CITY OF ALBUQUERQUE

Planning Department
Brennon Williams, Director

RE: 906 Ganado Ct. SE
Grading and Drainage Plan
Engineer's Stamp Date: 07/24/21
Hydrology File: M22D019

ENGINEER'S SEAL 7/24/21 DAVID SOULE P.E. #14522	LOT 56 BLK 10 FOUR HILLS VILLAGE 906 GANADO CT SE	DRAWN BY DEM
	GRADING AND DRAINAGE PLAN	DATE 7-24-21
	 RIO BOX 53924 ALBUQUERQUE, NM 87199 (505) 321-9099	SHEET # C1 JOB #

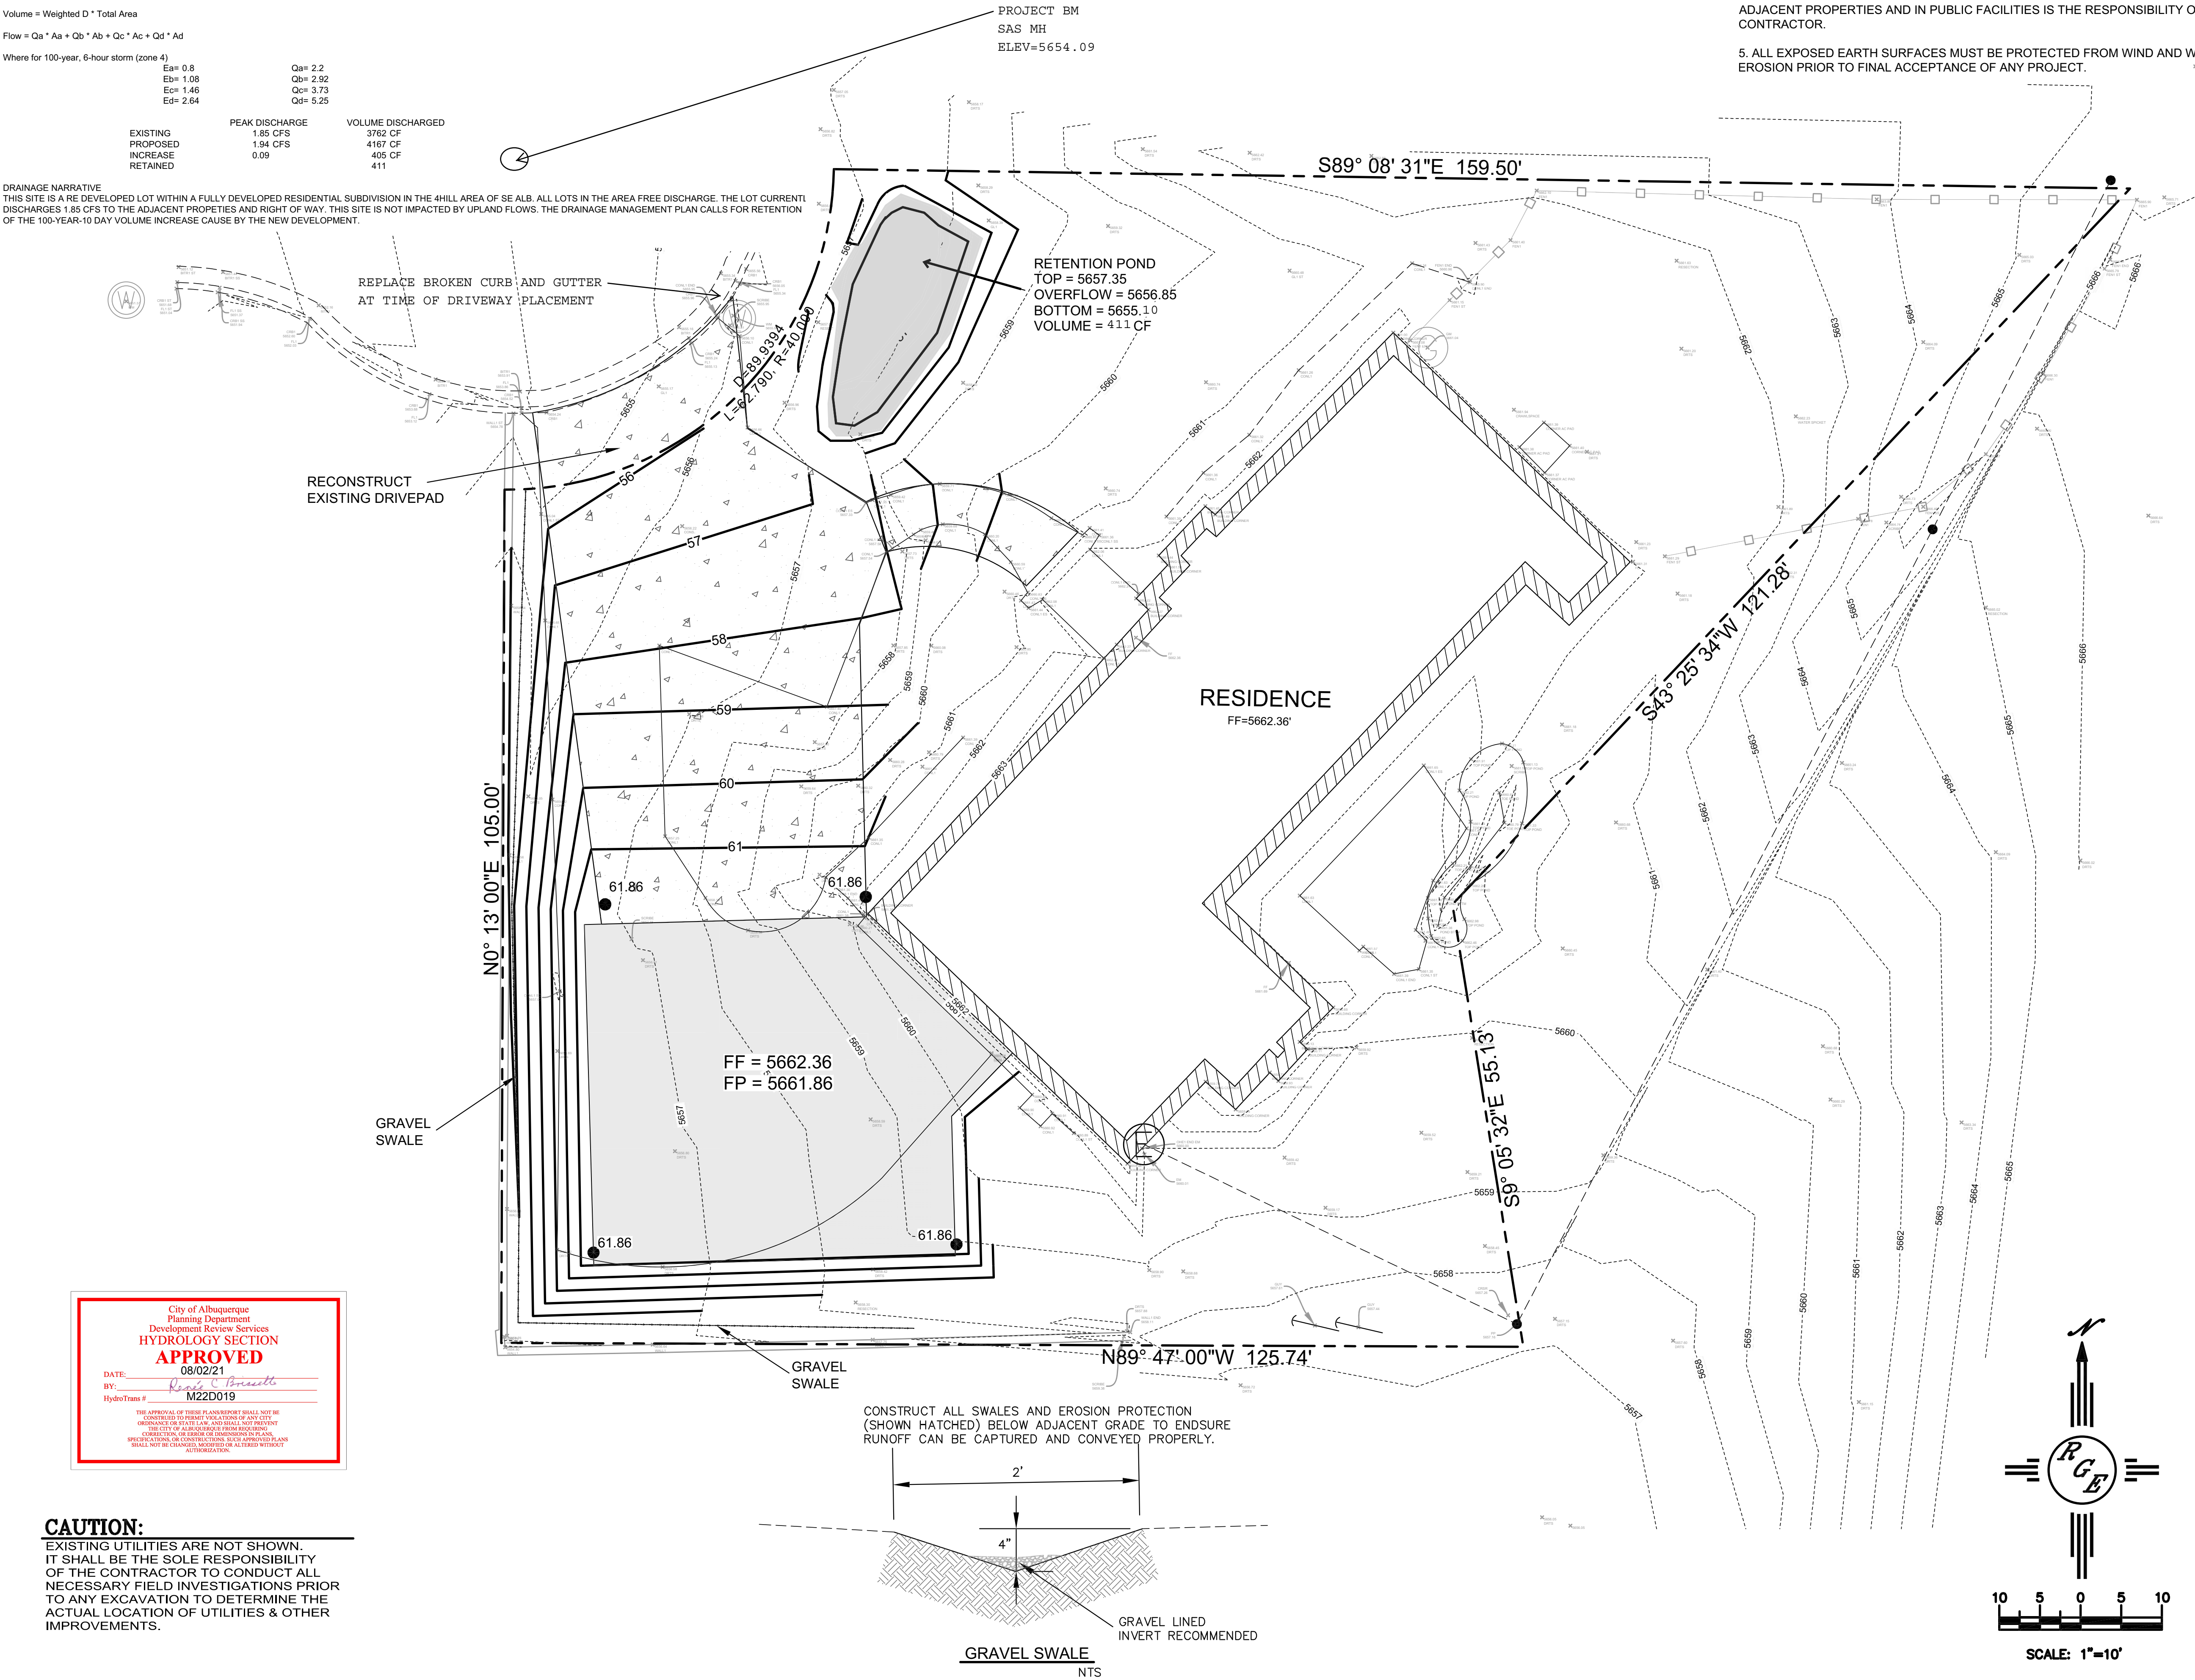
Based upon the information provided in your submittal received 07/26/2021, the Grading and Drainage Plan is approved for Building Permit and Grading Permit. Since this site has an existing home and appears to have need little grading for the proposed building, a pad certification is not needed for this project.

Please attach a copy of this approved plan in the construction sets for Building Permit processing along with a copy of this letter. Prior to approval in support of Permanent Release of Occupancy by Hydrology, Engineer Certification per the DPM checklist will be required.
